402™, 502™, 802® II Controllers

180520

Figure correction in service manuals

November 1, 1994

Corrected block diagram

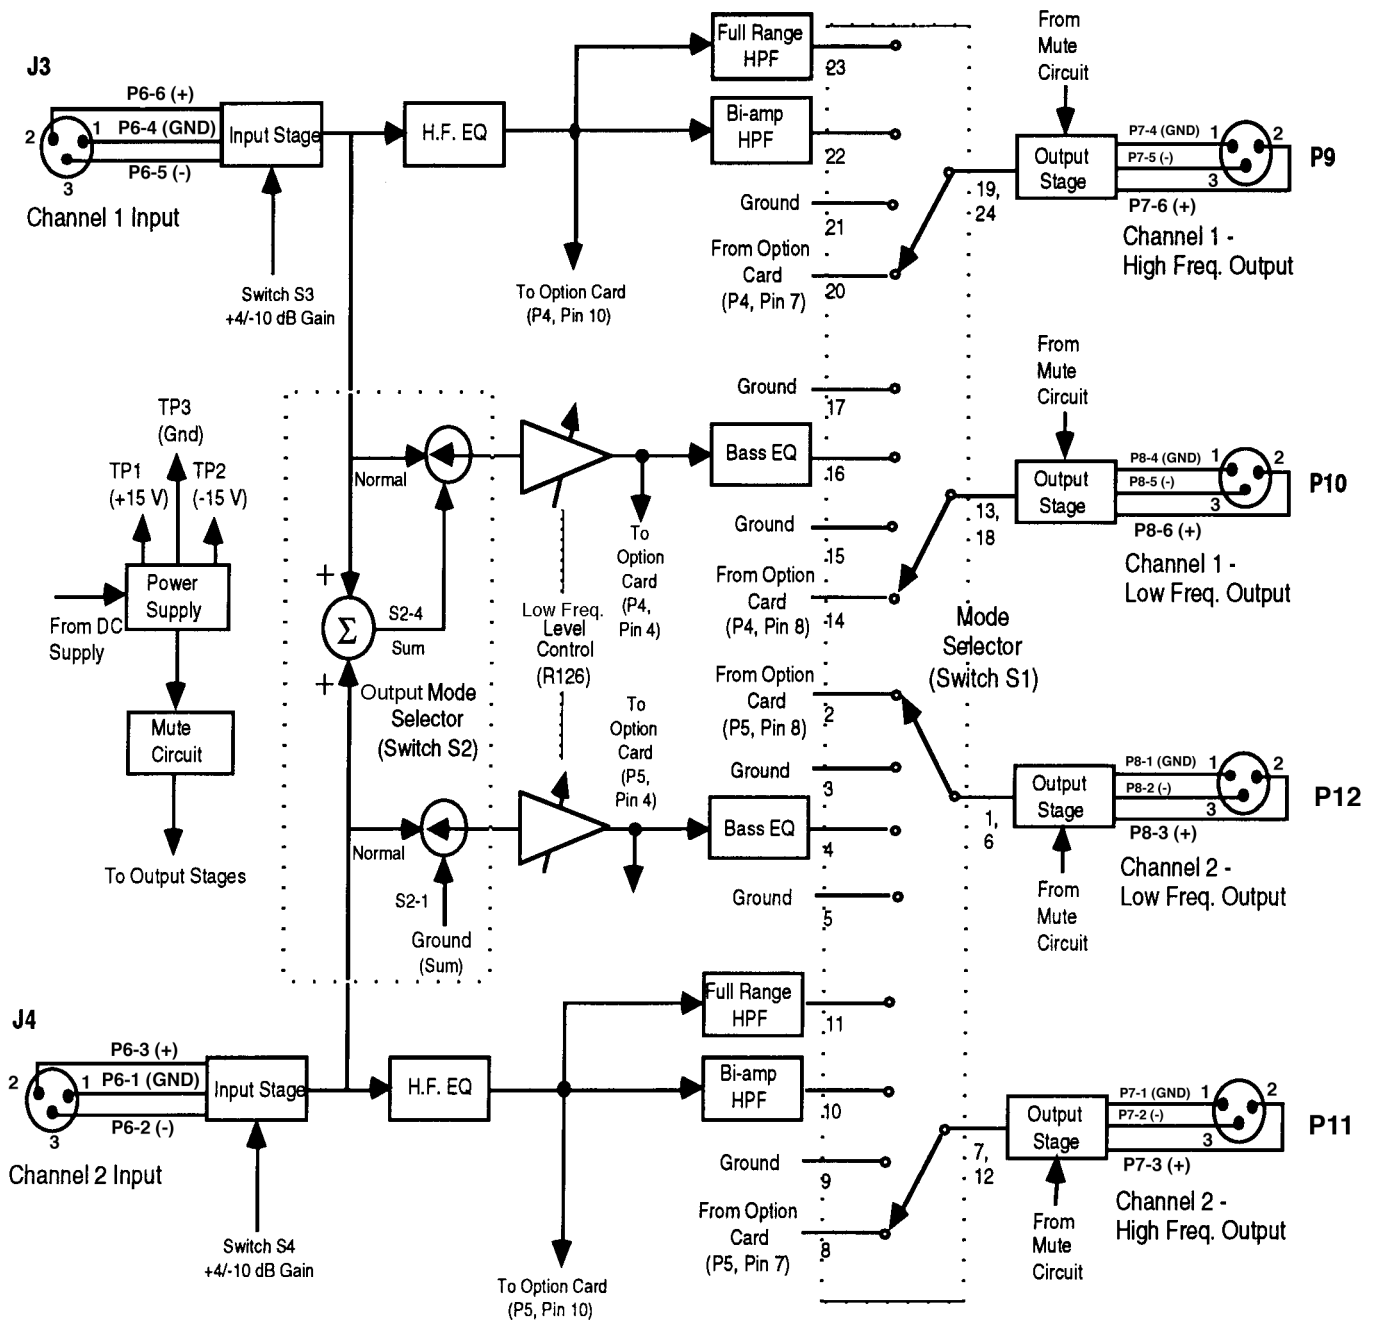
The block diagram in these manuals is incorrect. This affects the following figures:

502 manual (P/N 170310) Figure 12

402, 802 II manual (P/N 174785) Figure 22

For example, in the original block diagram, for the **Channel 1 High Frequency Output, P7-6 (+)** is shown connected to **pin 3**. In reality, it's connected to **pin 2**. All output connections have been corrected in the new diagram. This agrees with the controller schematics in both manuals.

Additionally, the **Channel 2 High and Low Freq. outputs** had their connections listed backwards. **P11 (Low Freq.)** is now **P12**, and **P12 (High Freq.)** is now **P11**.

A corrected block diagram is attached. This replaces both figures mentioned above.
